Public Service Electric and Gas Company 80 Park Place Newark, N.J. 07101 Phone 201 430-7000

DEGRADED GRID VOLTAGE PROTECTION (70-90%)
SUPPLEMENTAL INFORMATION
SALEM GENERATING STATION
UNITS NO. 1 AND 2
DOCKET NO. 50-272

ENCLOSURE 1

FIGURE 1

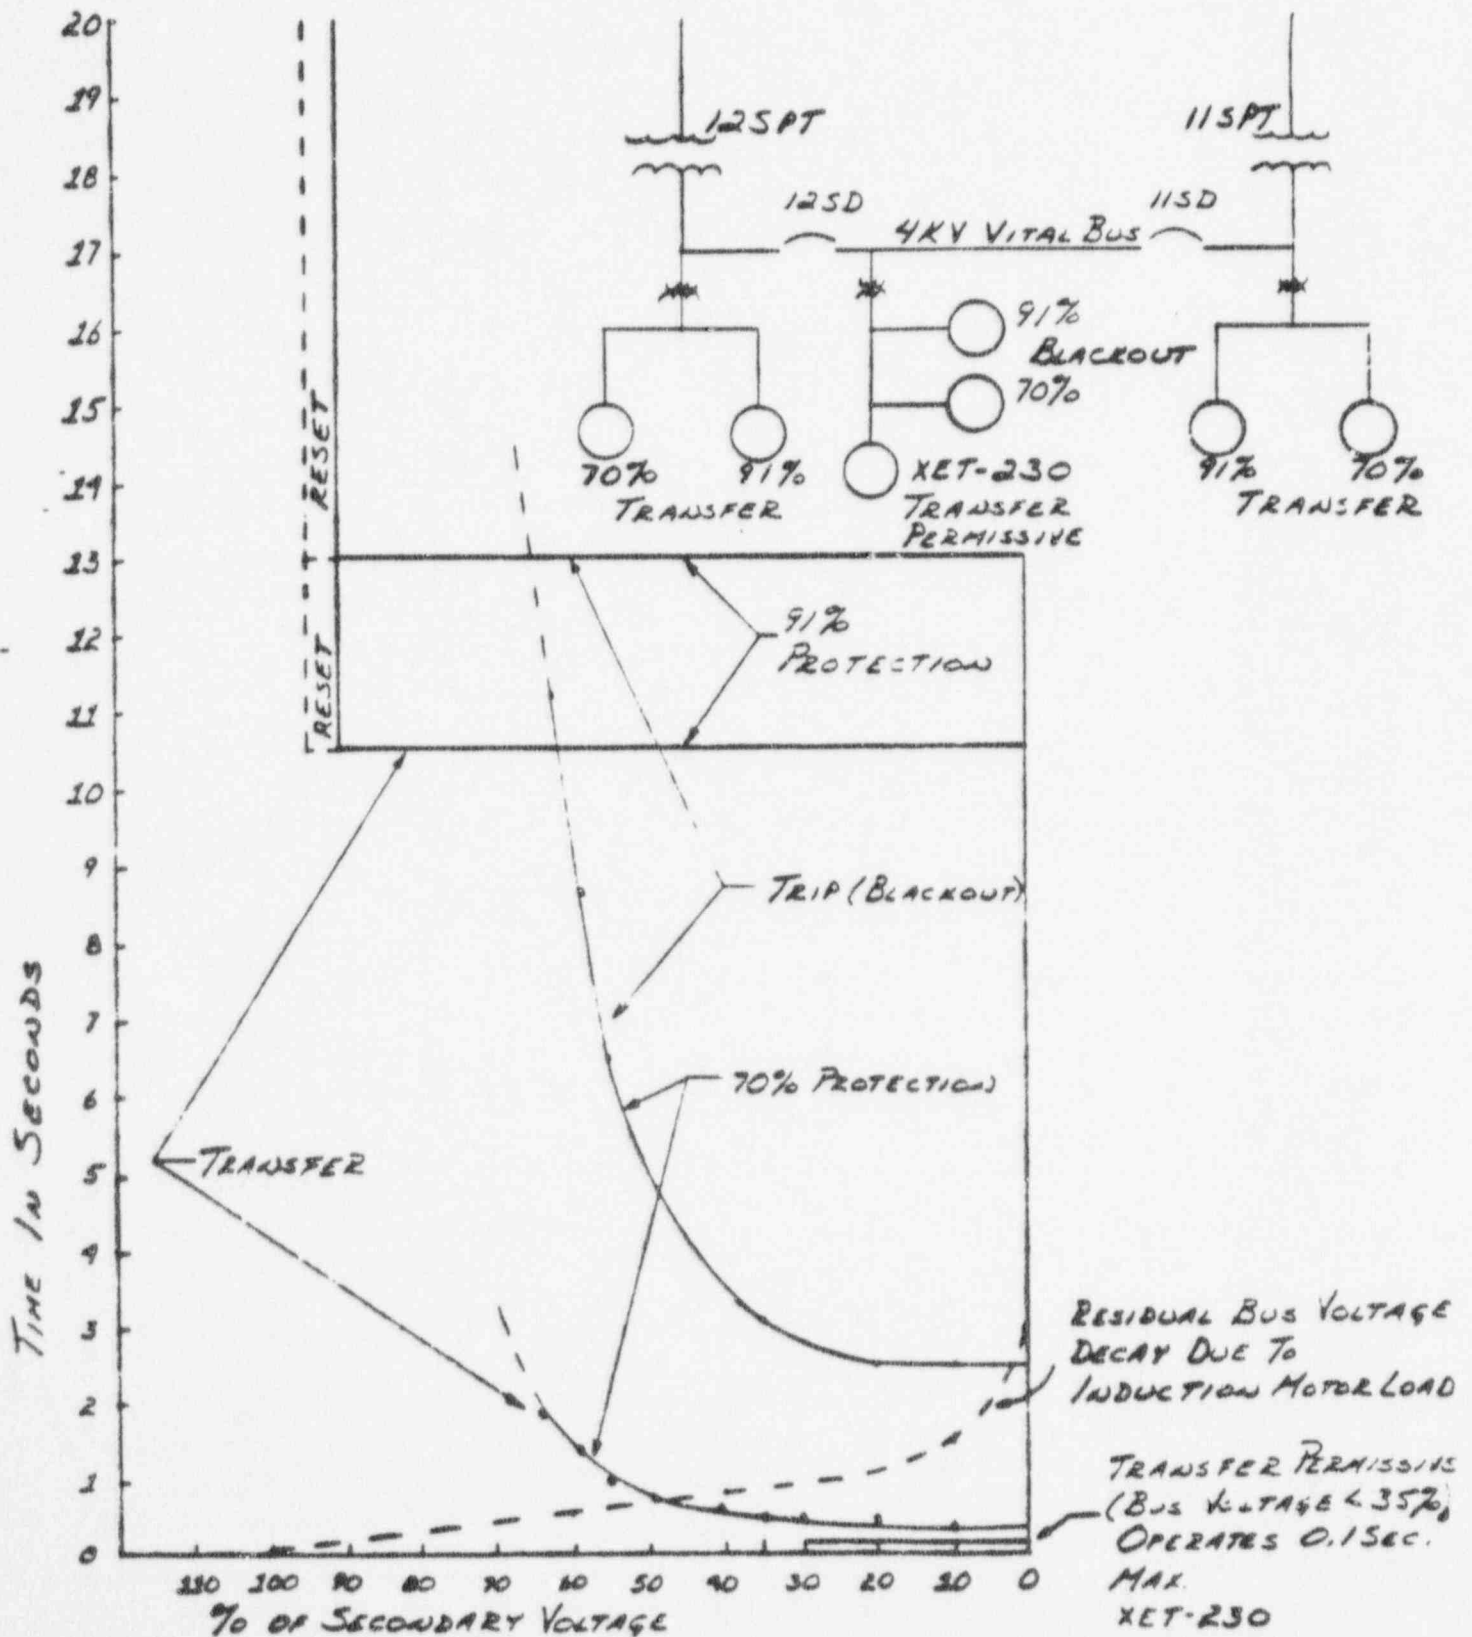
The time delay of the 91% undervoltage transfer relays will be 10.5 seconds when the output of the station power transformers is below 91% of its rated value (Figure 1).

The time delay of the 91% bus "blackout" relays will be 13 seconds when the voltage on the affected bus (or buses) is below 91% of rated value (Figure 1).

In the event the supply voltage to a 4 KV vital bus or buses falls below 91% of its rated voltage, the affected bus or buses will be automatically transferred to the alternate source by the action of the vital bus transfer relay (XET-230, Fig. 1) and the 91% transfer relays after a 10.5 second time delay.
